**CULTURAL RESOURCES OFFICE
 PRESERVATION BOARD
 REGULAR MEETING**

MONDAY MARCH 27, 2017 — 4:00 P.M.
1520 MARKET ST. #2000, ST. LOUIS, MO. 63103
www.stlouis-mo.gov/cultural-resources

CITY OF ST. LOUIS
**PLANNING & URBAN
 DESIGN AGENCY**
 CULTURAL RESOURCES OFFICE
 FRANCIS G. SLAY, Mayor

DELMAR STREETSCAPE WITH PROPOSED BUILDING

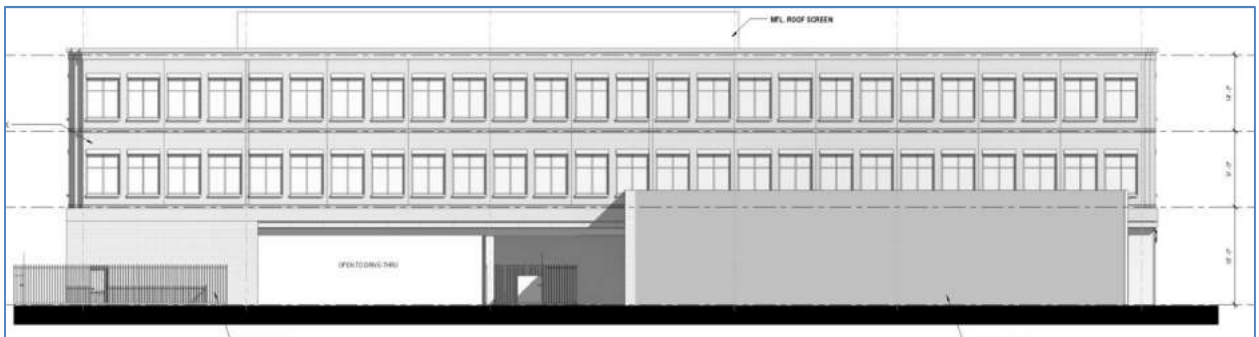
The 3-story building is a story taller than the historic commercial buildings immediately adjacent to its west. However, there is a variety of building heights along Delmar: the 4-story Southwestern Bell building, directly opposite; and another 3-story building and the 7-story Moonrise Hotel on the block to the east.

Complies. Brick is proposed for the majority of the exterior of the building, including its side and rear elevations. At the first story, pilasters of stone veneer flank the contemporary metal storefronts

Mostly complies. The articulation of the building breaks it visually into vertical bays and other elements that are of comparable scale and rhythm to those on historic buildings. Individual window opening proportions are comparable. The larger glazed section at the corner is the only deviation and contributes to visually reduce the building's scale.

RECOMMENDATION:
 That the Preservation Board grants preliminary approval to the proposed design with the stipulation that final plans and exterior materials are reviewed and approved by the Cultural Resources Office.

RENDERING OF REVISED PROPOSAL

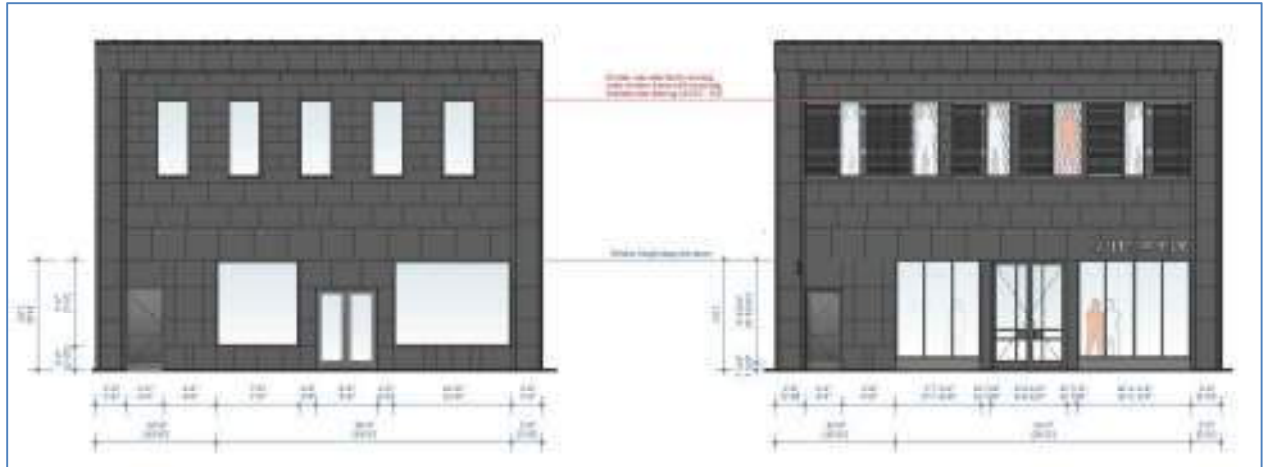
Partly complies. The current proposal will retain the separations between the entry and flanking shop windows. However, it still raises the height of the door and lowers the shop window, installing a 12-inch black granite bulkhead instead.

The “grills” are not supported by the ordinance. However, the new proposal increases the visibility of the window openings by increasing the transparency of the “grills”. The new proposal has “grills” on sliding metal runners that extend across the façade. These will be adjustable to interact with display boxes behind the second story windows.

Does not comply. New modifications are less intrusive than the previous proposal. Still, the storefront is altered and not restored.

Based on these preliminary findings, the Cultural Resources Office recommends preliminary approval for storefront alterations with staff consultation regarding final design details.

**STREET ELEVATION, SOUTH SIDE OF WASHINGTON PLACE
WITH PROPOSED DEVELOPMENT**

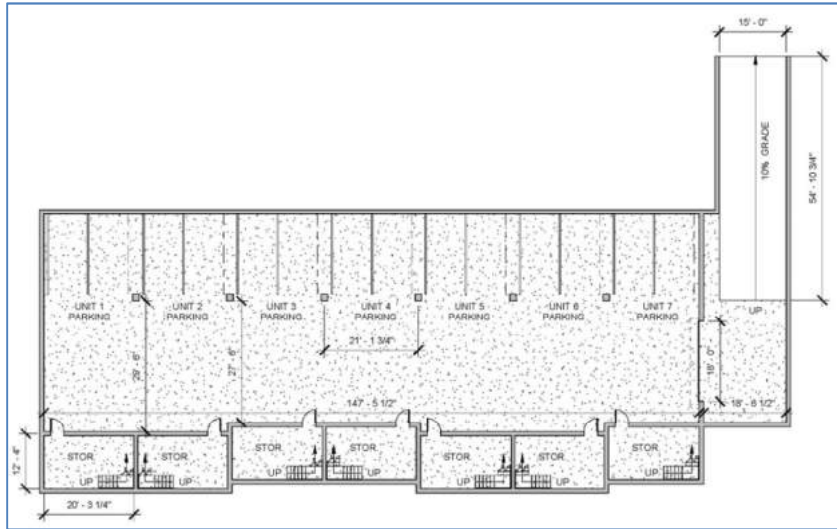
Partly complies. The height of the proposed building is generally consistent with other buildings on Washington Place. Floor heights will also be similar. But the massing of the new building does not comply; the building is substantially wider than the detached houses of Washington Place and the individual units much narrower.

Complies partially. The width of the building façade is far greater than any other structure on Washington Place and does not continue the rhythm of the street. However, the proposed building's setback from the adjacent building to the west is within the 10 percent requirement and the front setback is maintained.

Does not comply. While windows in the proposed design are generally similar in proportion to historic windows, the percentage of glazing on the front elevations is substantially greater than that of adjacent buildings.

Based on these preliminary findings, the Cultural Resources Office recommends that the Preservation Board withhold preliminary approval of the proposed design as it does not comply with the Central West End Local Historic District standards.

PROPOSED NEW CONSTRUCTION

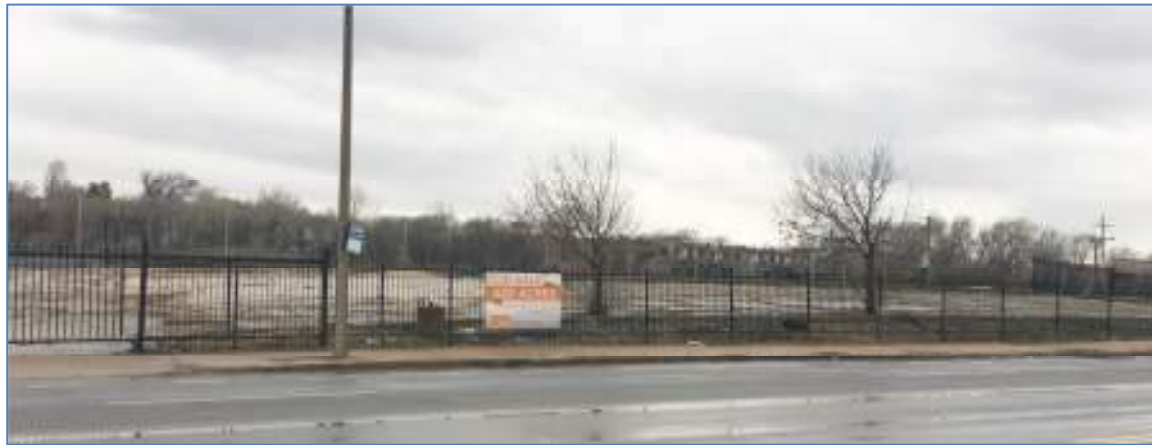
- The building has an appropriate scale and detail.
- The street façade materials will brick, and meet the standards for façade materials. The lap siding proposed for the majority of the west elevation and the rear does not meet the standards.

Based on the Preliminary findings, the Cultural Resources Office recommends that the Preservation Board grant preliminary approval for the new construction, with the stipulation that final drawings, materials and colors be reviewed and approved by the Cultural Resources Office.

TYPICAL REAR ELEVATION WITH BASEMENT GARAGE

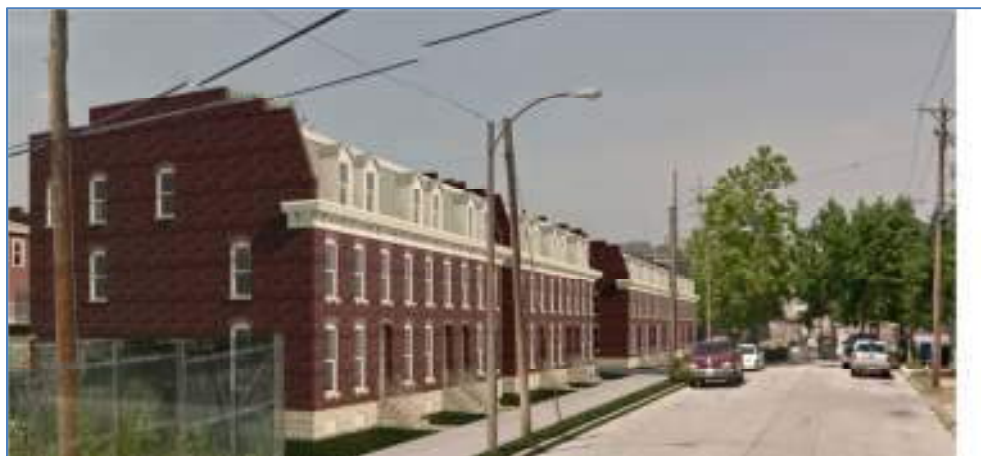
- The HME submitted is a detached single-family; buildings proposed are three- and four-unit townhouses;
- The roof shape does not follow the HME; however, the design has been modified to disguise the non-conforming shape;
- The rear elevations will be sided; the HME has four sides of brick.

- Rear elevations of units that are prominently visible from a public street (i.e. corner units) shall be brick.
- Both north and south sides of the re-opened LaSalle Street shall have sidewalks.
- Final plans and exterior materials shall be reviewed and approved by the Cultural Resources Office.
